RE: Data Response, Set 1A  
Ivanpah Solar Electric Generating System (07-AFC-5)

# **Ivanpah Solar Electric Generating System (ISEGS)**

## **Data Response, Set 1A**

**(Response to Data Requests 1 through 116)**

**FIGURE DR4-1  
AREA FOR ADDITIONAL  
HELIOSTATS**  
IVANPAH SOLAR ELECTRIC GENERATING SYSTEM

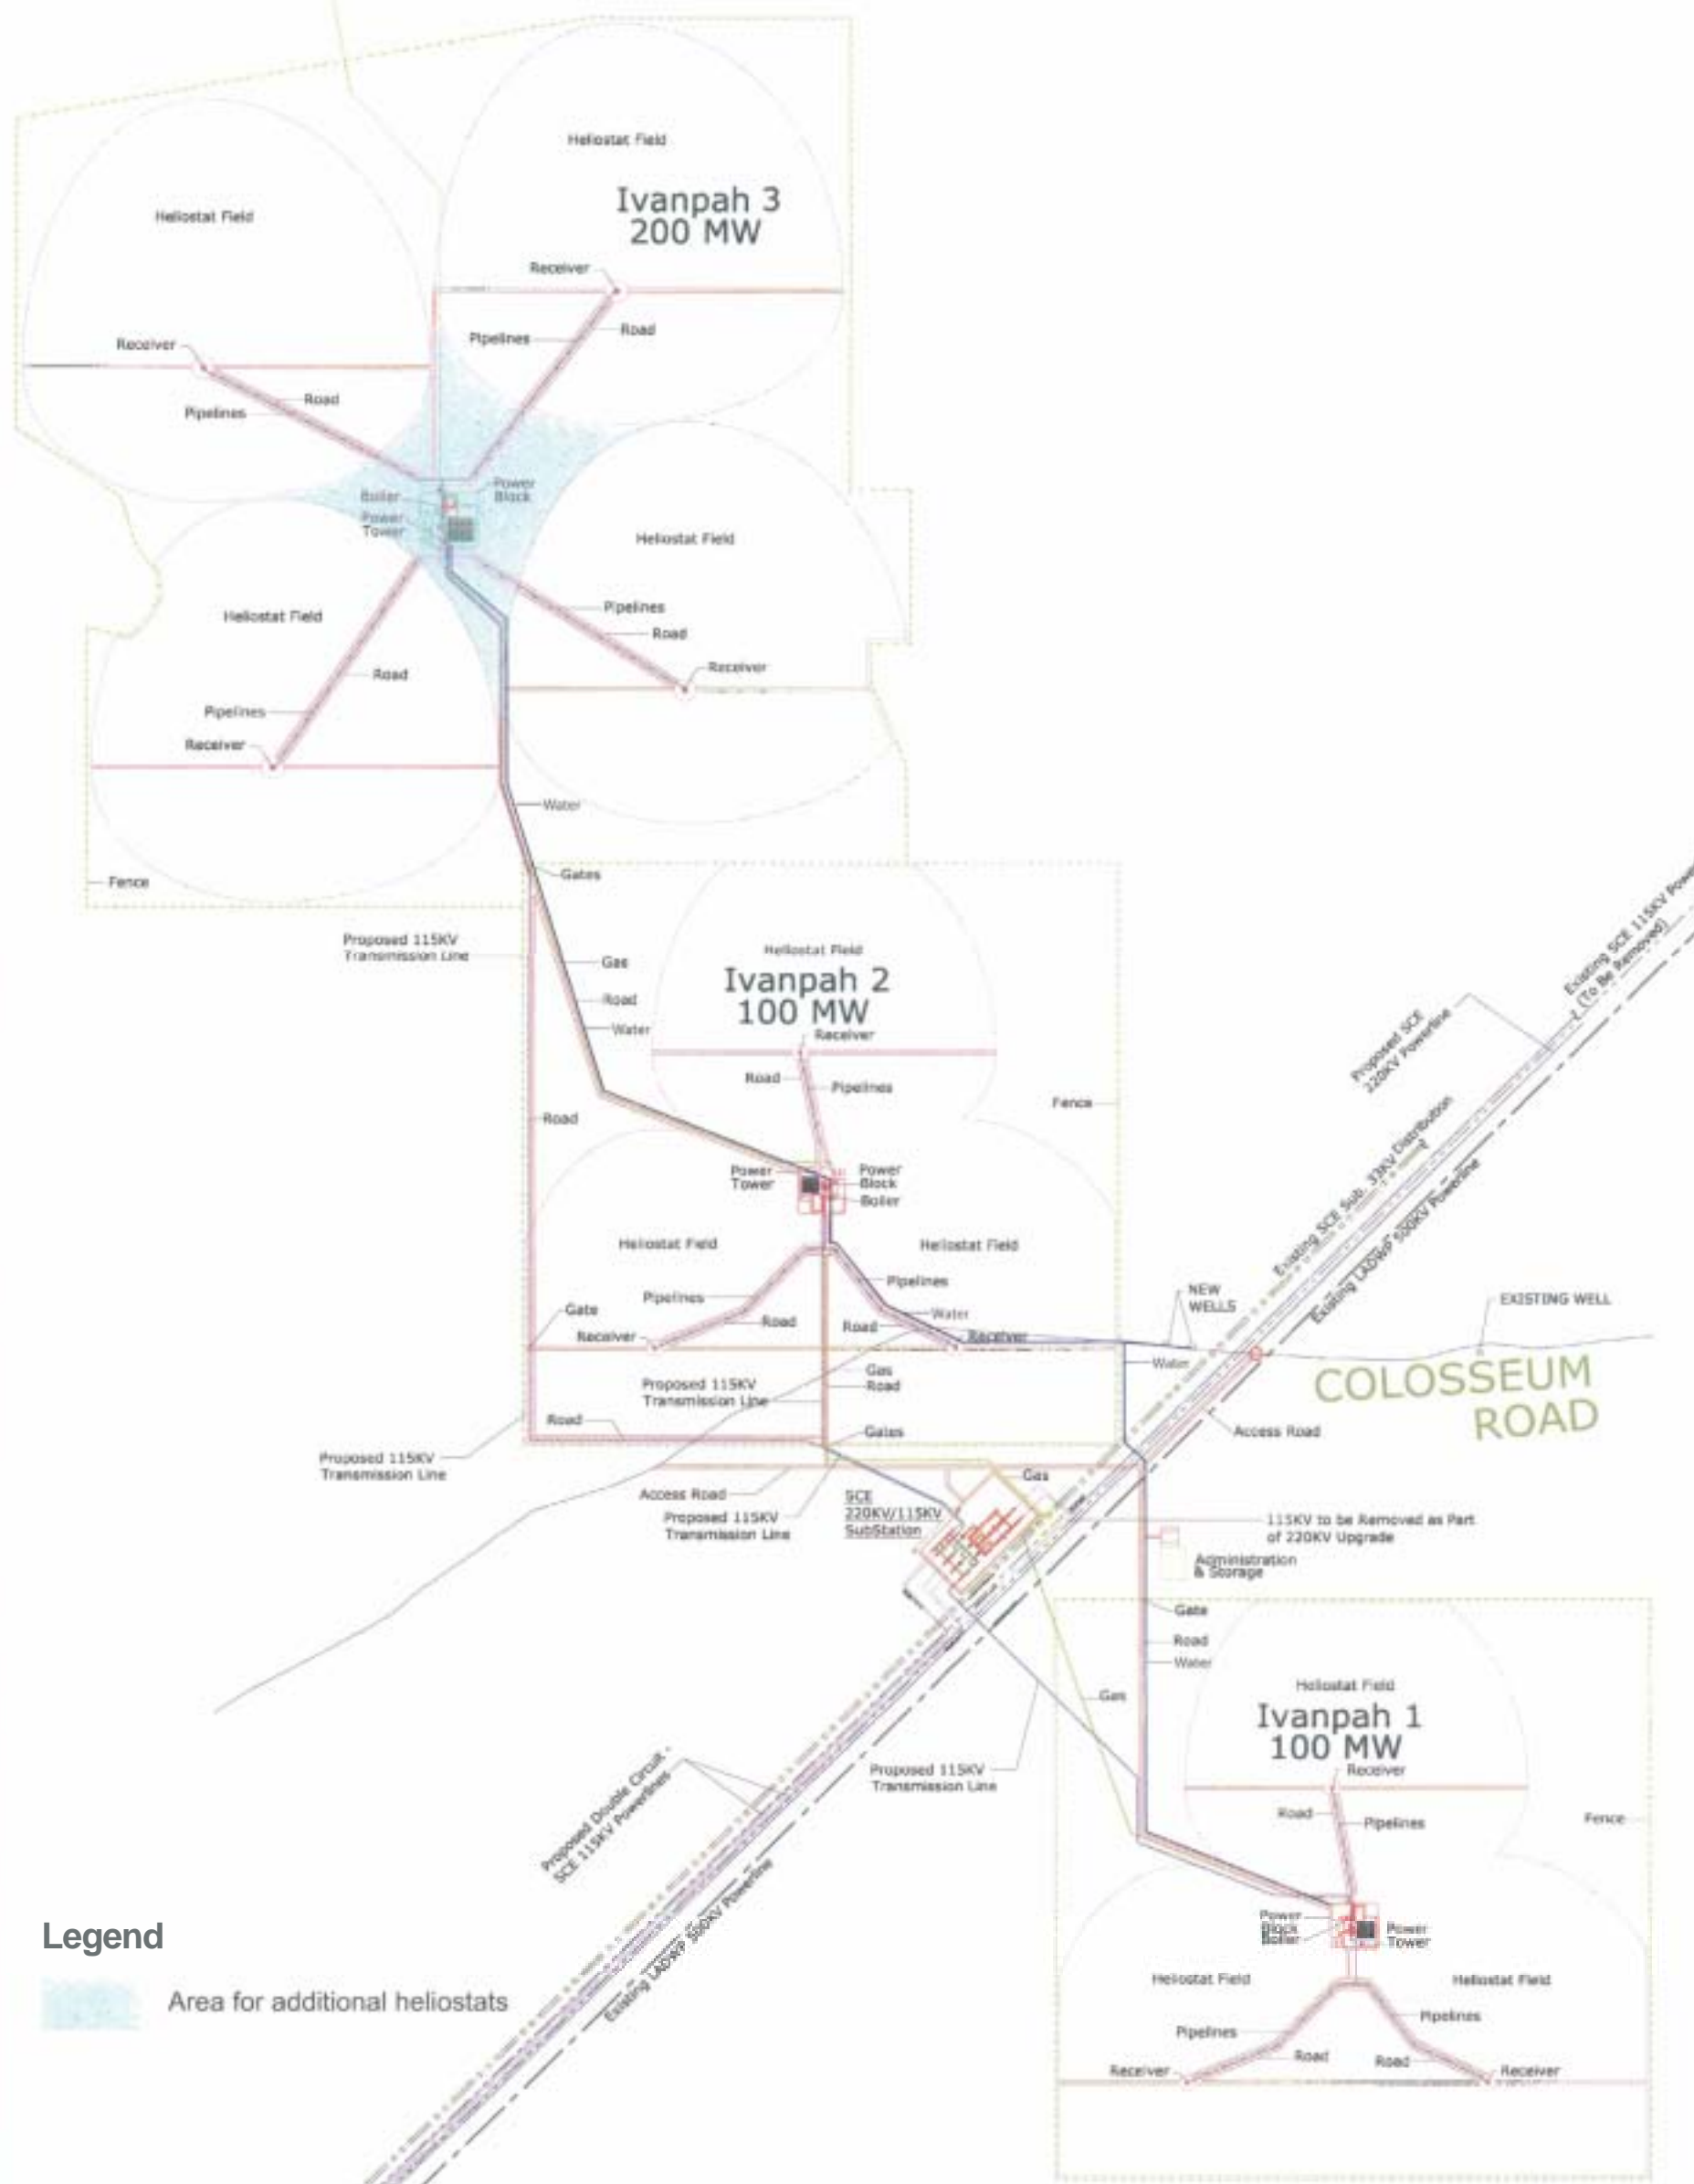
Plan of Development, 2.2 Process Description cites "Additional heliostats would be located outside the power block perimeter road, focusing on the reheat tower. Their

**Response:** The statement refers only to the Ivanpah 3 plant of 200MW, the intention being to install additional heliostats inside the area formed between the four solar fields, as shown on the attached drawing Figure DR4-1. This area (excluding the power block) is approximately 101.2 acres and is included as part of the project’s 3,400-acre total.

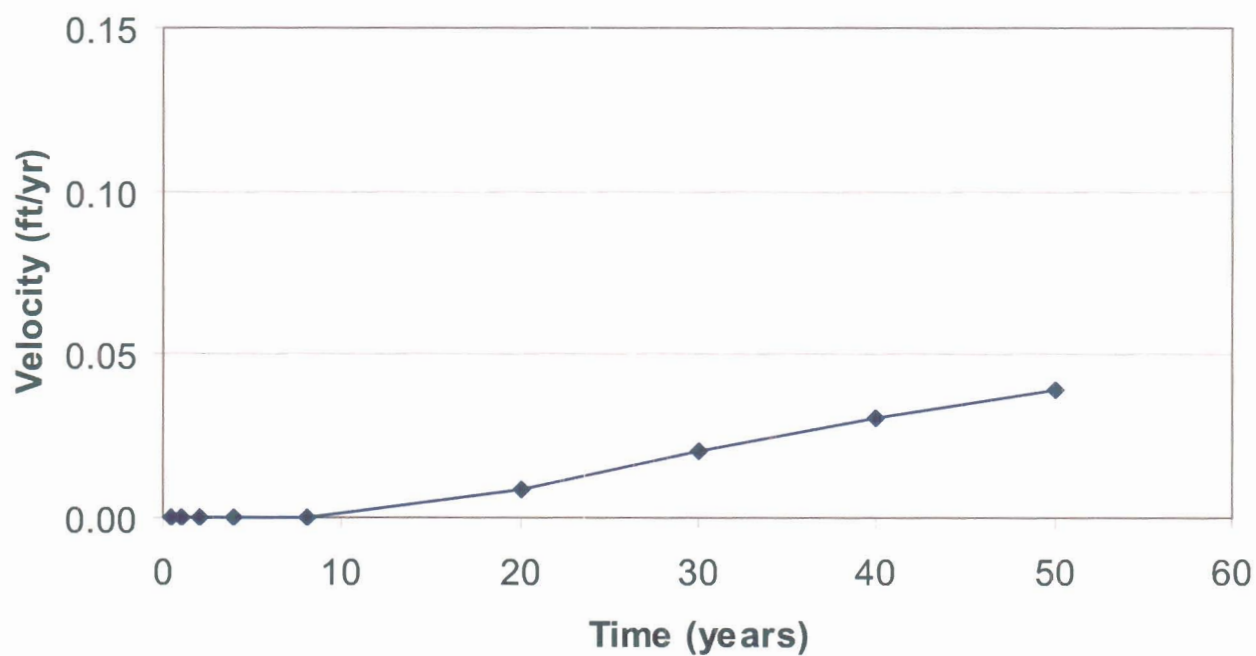
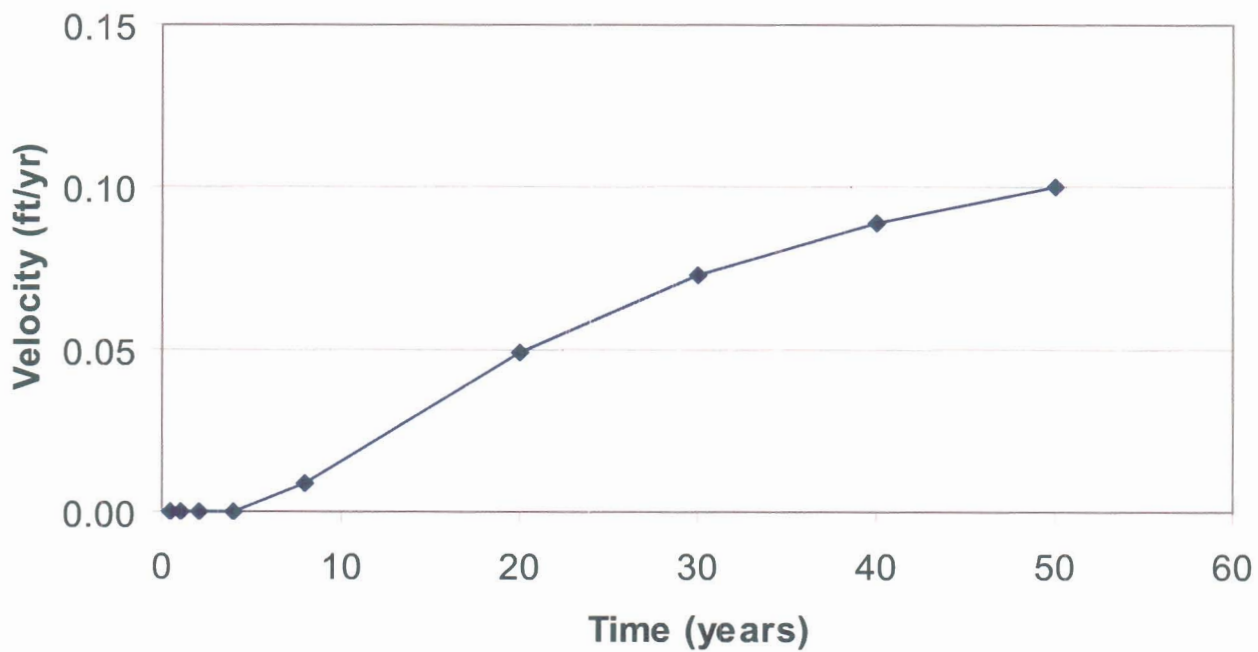
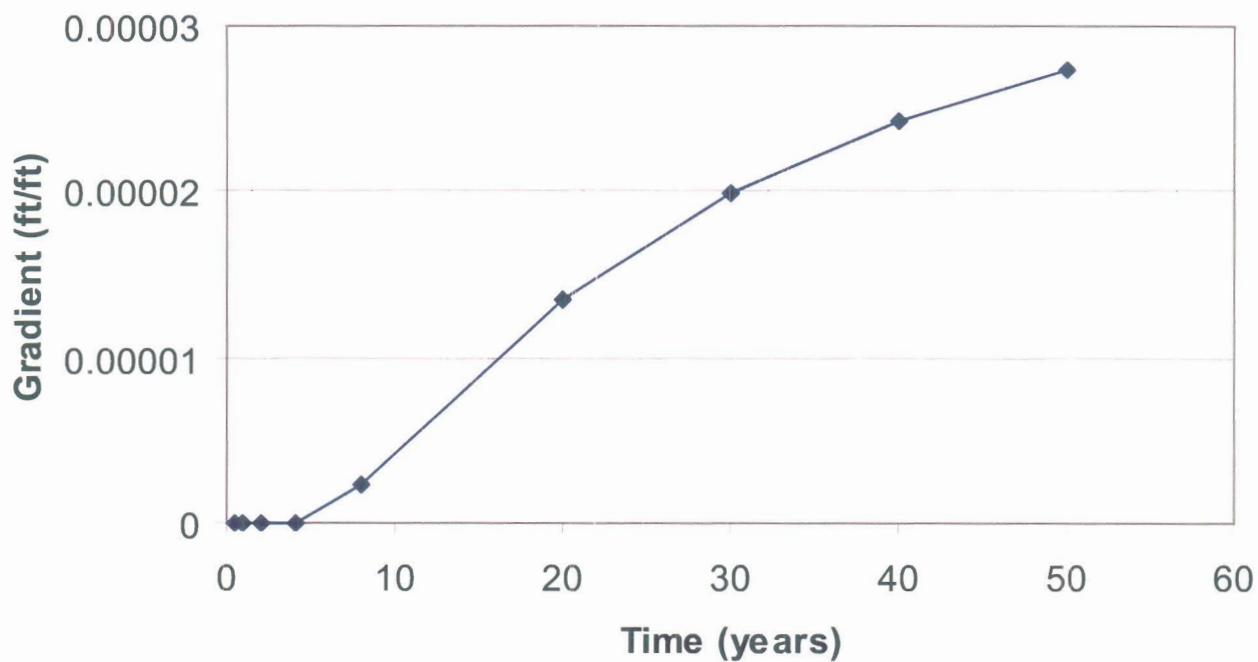
80. Please show the location of the proposed water tanks and distribution lines on a revised Figure 5.15-2 (Major Hydrologic Features In and Near the Project Site).

**Response:** The scale of AFC Figure 5.15-2 has been revised to allow the power block to be shown. Each phase is shown in a separate figure. Figure DR80-1a is Ivanpah 3, Figure DR80-1b is Ivanpah 2, and Figure DR80-1c is Ivanpah 1. The location of the water tanks is indicated on each figure.
